Determination 2022/015

Regarding the compliance of a 1200mm high masonry swimming pool wall with Building Code Clause F4 Safety from falling, and whether to grant a modification of Clause F4.3.1.

106 Kopanga Road, Havelock North

Figure 1 (above): Plan (Not to scale)

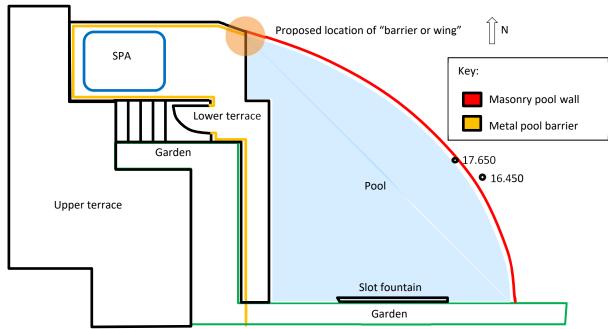
- 2.1. In May 2017, the owner obtained a building consent to make additions and alterations to an existing residential property. Specifically, for the addition of a bedroom, ensuite, new woodburning fire with wetback, stand-alone garage/workshop and new swimming pool.
- 2.2. The swimming pool is located on the north-eastern corner of the property. The north-eastern pool wall follows a curvature from its northern most point to its south-eastern most point (see Figure 1). The plans submitted with the building consent state the north-eastern pool wall is a "masonry swimming pool wall 1200mm high..." and is said to be an "effective pool fence³". The spot levels⁴ in the plan (see Figure 1) confirm the height of the masonry pool wall to be 1200mm.

2.3. The top of the masonry pool wall is 240mm in width and is inward sloping on a 15-degree angle (see Figure 2). The width, slope, and height of the masonry pool wall is the same along its entire length. The surface of the top of the pool wall has sloped

- 2.4. To the west of the pool is a split-level terrace (see Figure 1). The upper terrace contains a paved patio area, and the lower terrace contains a spa and pool area. Five stairs lead from the upper to the lower terrace. Separating the entire upper and lower terraces is a metal pool barrier measuring 1200mm in height. At the bottom of the stairs, which leads from the upper and lower terraces, is a 900mm wide by 1200mm high gate. The gate has a latch. The gate opens inwards towards the stairs and away from the pool⁵; the gate is in the same position as the metal pool barrier. A thin strip of the lower terrace, 800mm wide, runs parallel to the western pool edge and widens out at the gate and spa area. Behind the metal pool barrier is a garden bed (which sits at the foot of the upper terrace). At the south end of the pool is a 'pool feature wall with slot fountain', and behind the slot fountain is a pool cover pit.

- 2.5. Beyond the masonry pool wall is a sloped grass/dirt area. This area accommodates a garden path leading to the north-eastern side of the property and comprises a wastewater treatment tank (see Figure 3).
